Subject: **Response to On Hold Letter** for request for Section 401 Water Quality Certification Modification, Wilmington Bypass from north of US 74/76 in Brunswick County to US 421 in New Hanover County. DWQ Project No. 10-0867v.4. TIP R-2633B.

Reference: NCDOT Modification Request, dated April 3, 2013
NCDWQ On Hold Letter, dated April 19, 2013, received April 26, 2013

Subject: Request for Modification to Individual Section 404 and Section 401 Water Quality Certification for the Wilmington Bypass from north of US 74/76 in Brunswick County to US 421 in New Hanover County. Federal Aid Project Nos. NHF-0017 (96) and STM-0017(97), WBS No. 34491.2.3, TIP No. R-2633B, DWQ Project No. 10-0867v.4

8/23/99
5/2/2013
R:\Hydro\pfiles\Permit\ssc\R-2633B.RDY_xpl.dgn

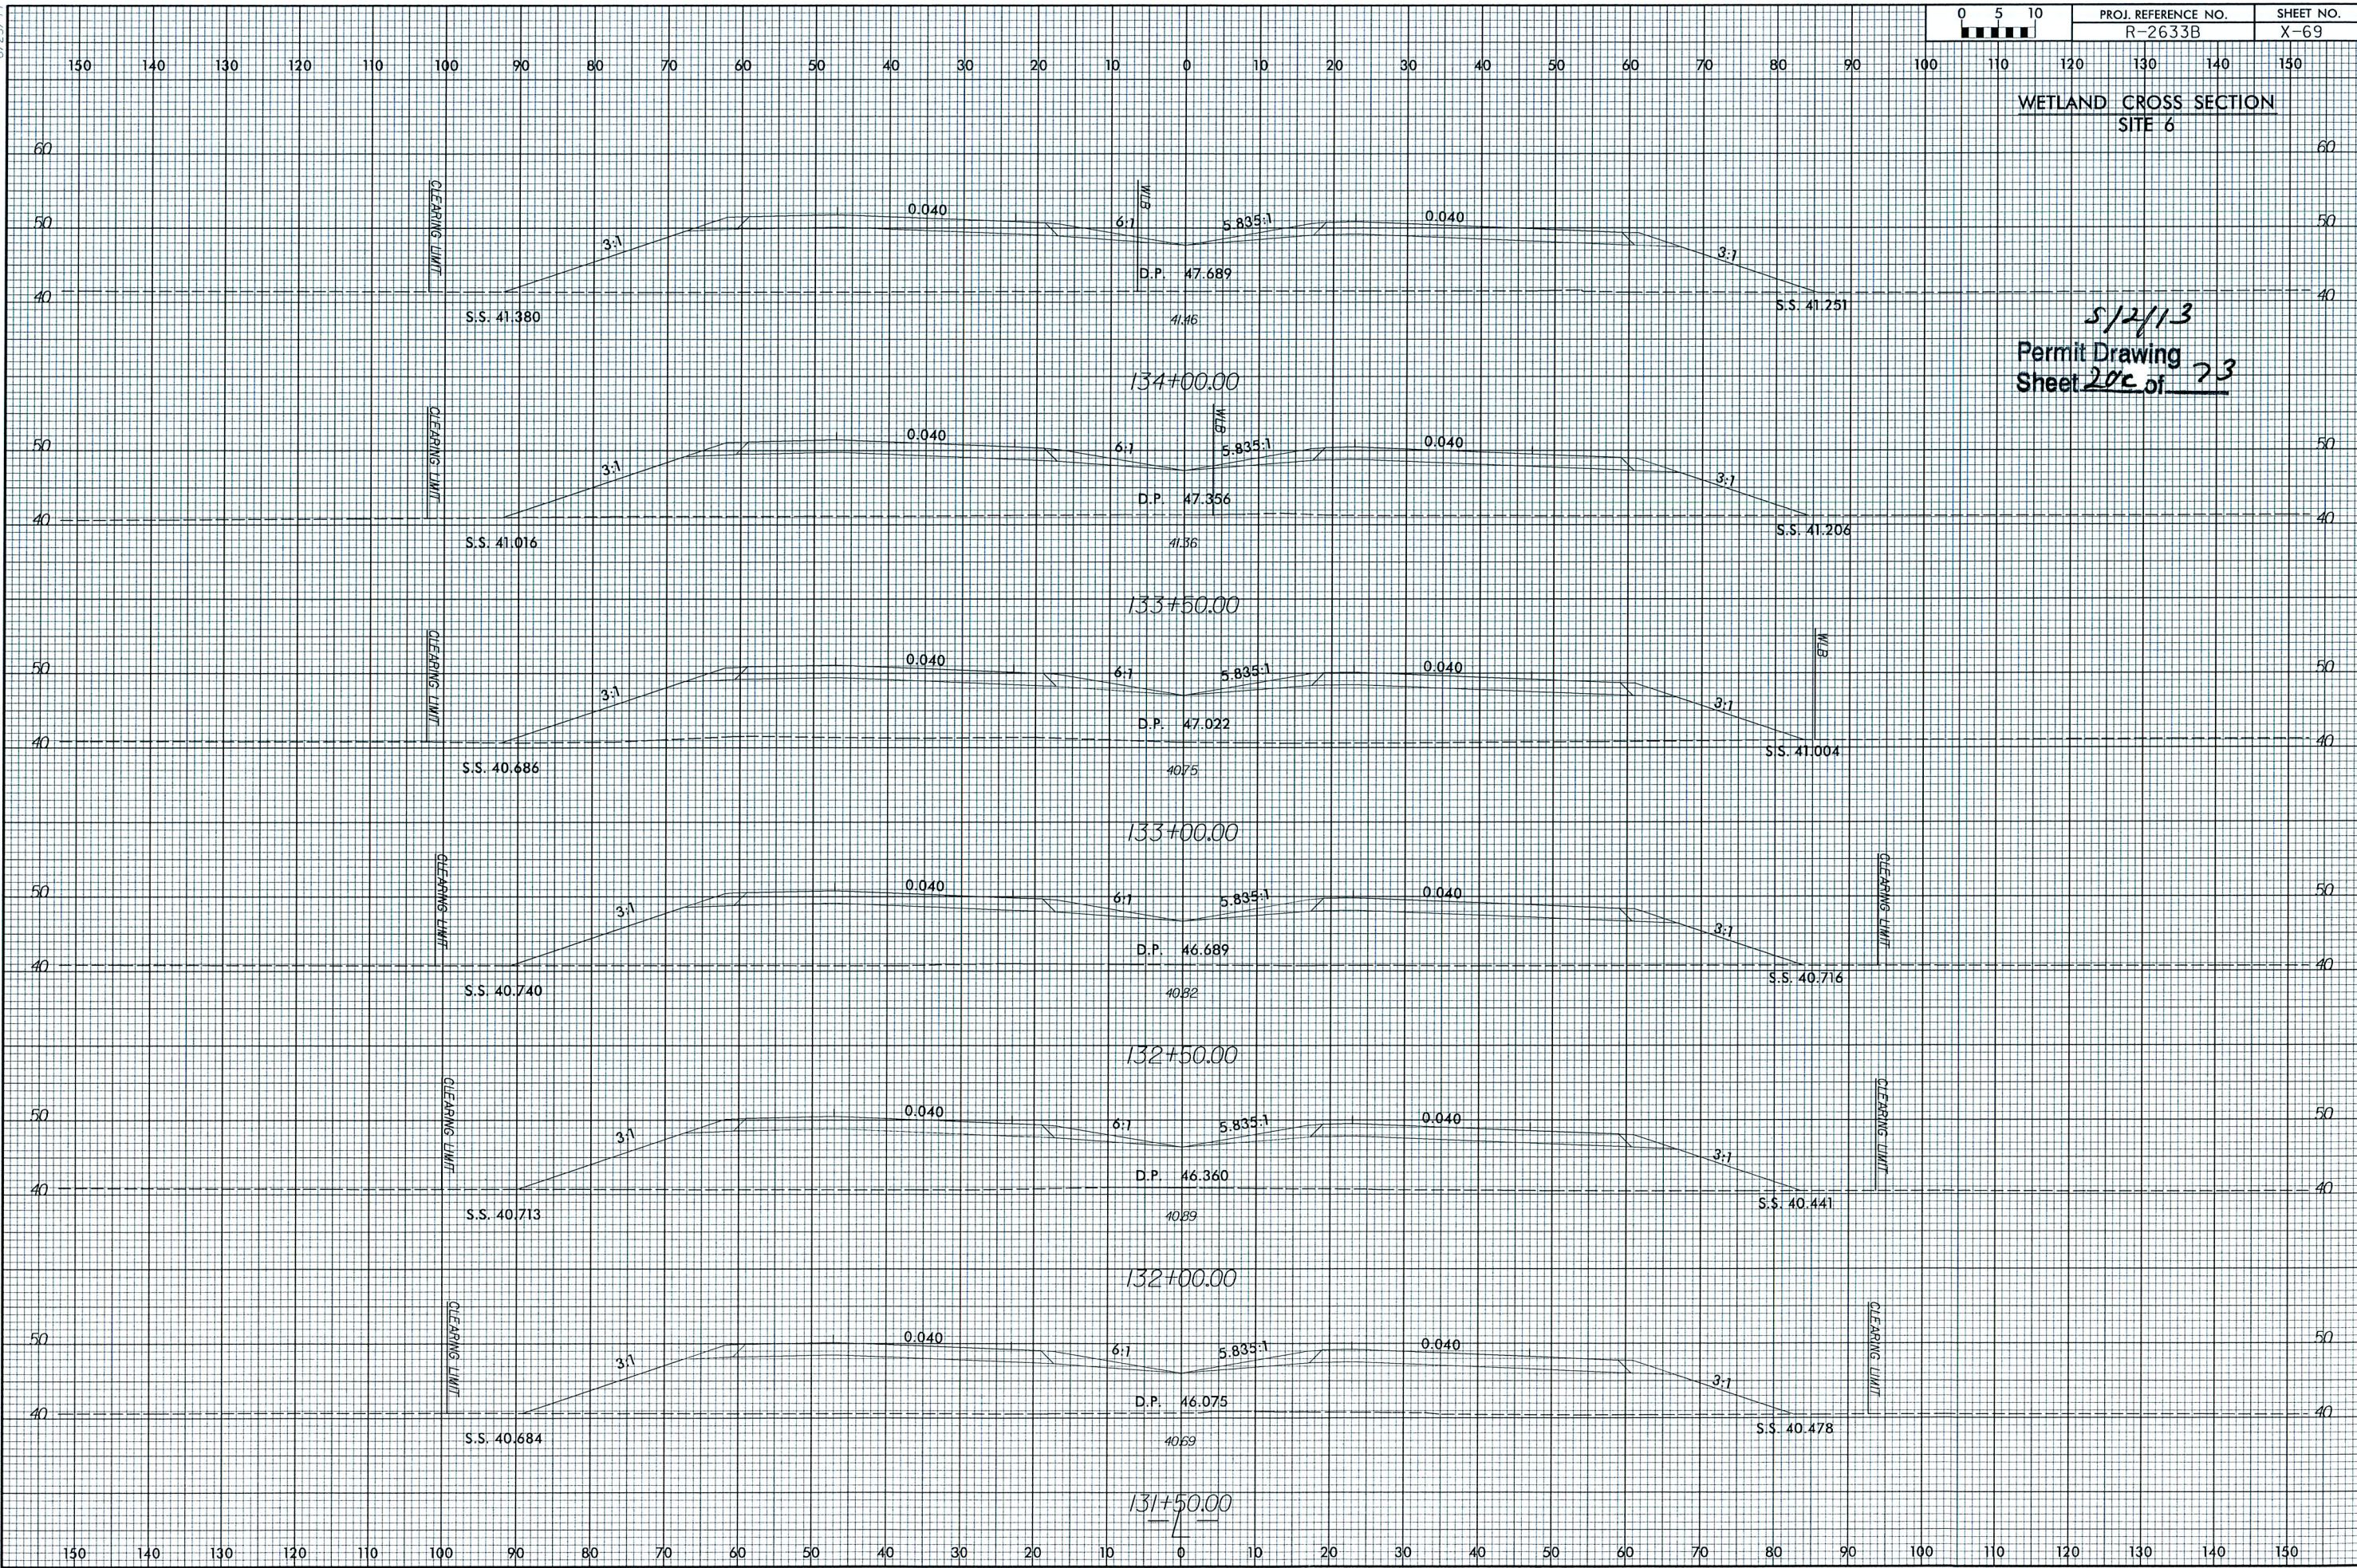
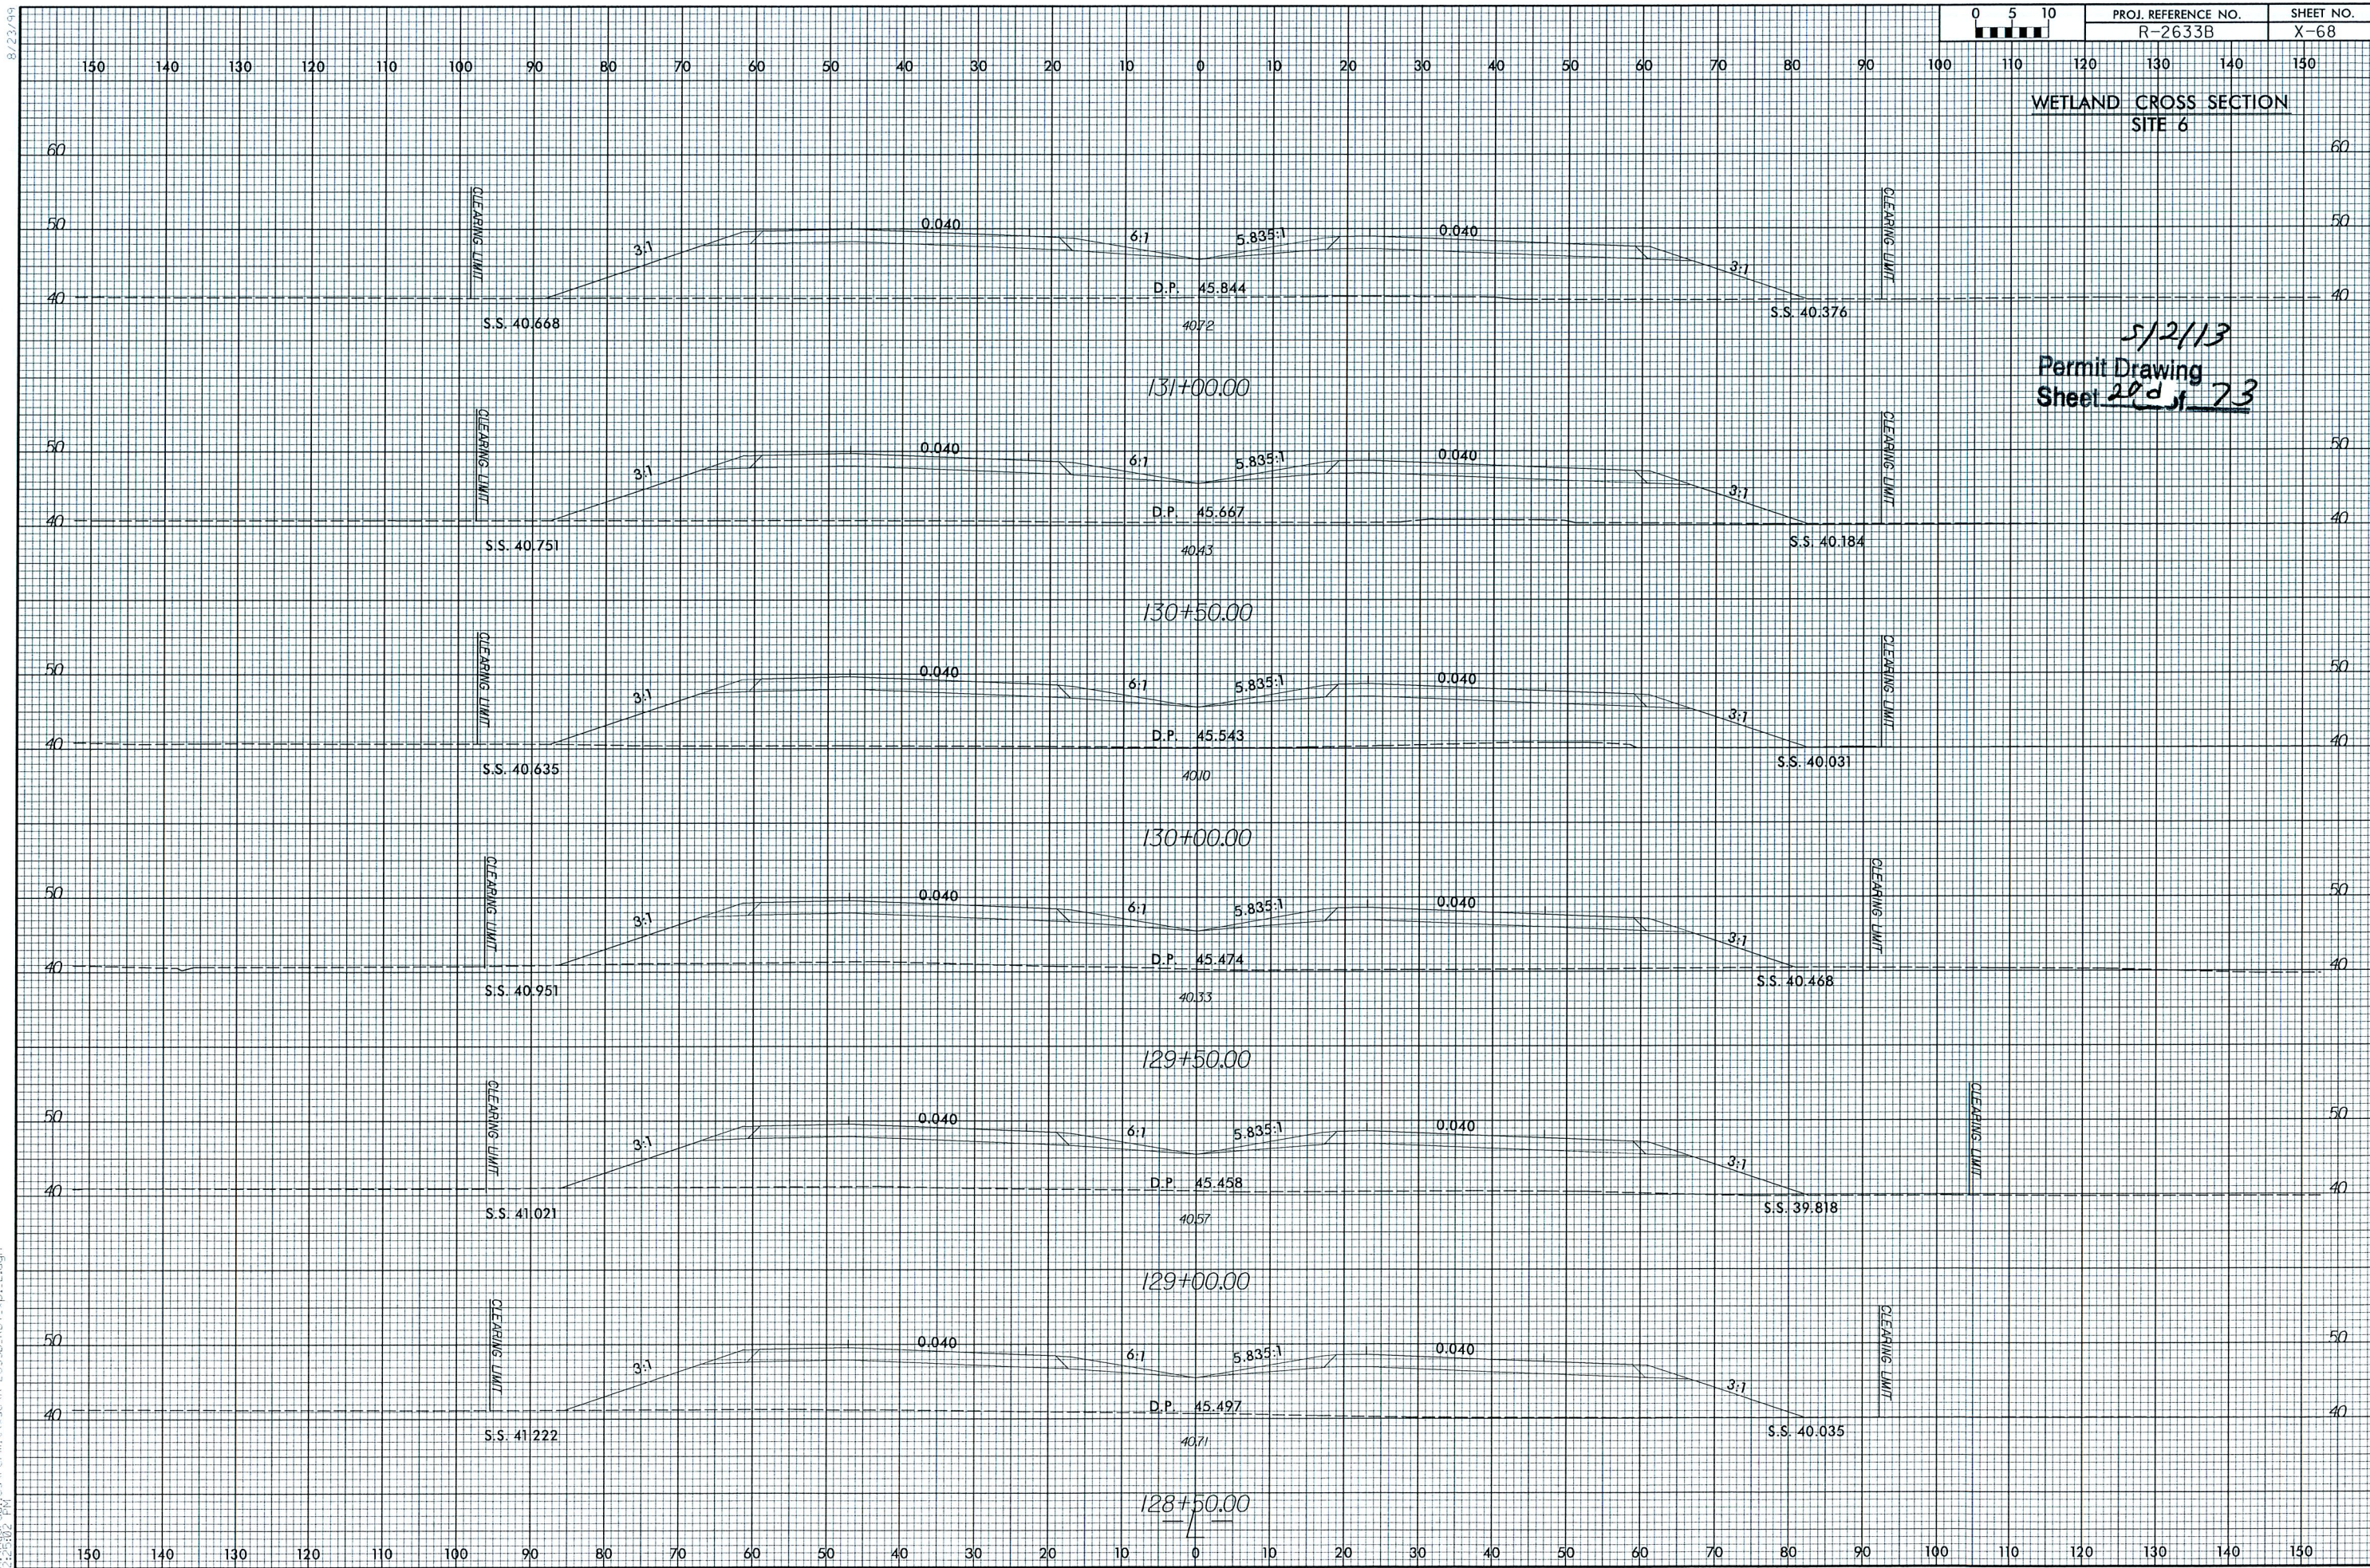
2. *Site 6 – no cross sections were provided for the wetland impacts between Sta. 109+28 to 118+00 and 123+00 to 135+00. Please provide these cross sections.*

2. Site 6 – no cross sections were provided for the wetland impacts between Sta. 109+28 to 118+00 and 123+00 to 135+00. Please provide these cross sections.

3. Your application states in the "Avoidance and Minimization" section that 3:1 slopes will be used in wetland areas to minimize wetland impacts. Upon review of the application there are several cross sections that show greater than 3:1 slopes. Please correct.

Representative cross sections were provided in the application. Nevertheless, additional cross sections are enclosed, providing a larger sampling of cross sections in jurisdictional areas.

Sites 3, 5 & 6 permit drawings, cross sections, and impact summary sheet have been revised and are enclosed. As a result, proposed permanent fill has decreased at these sites by 1.42 acres. Additionally, we will submit a revised request to EEP for an updated acceptance letter.
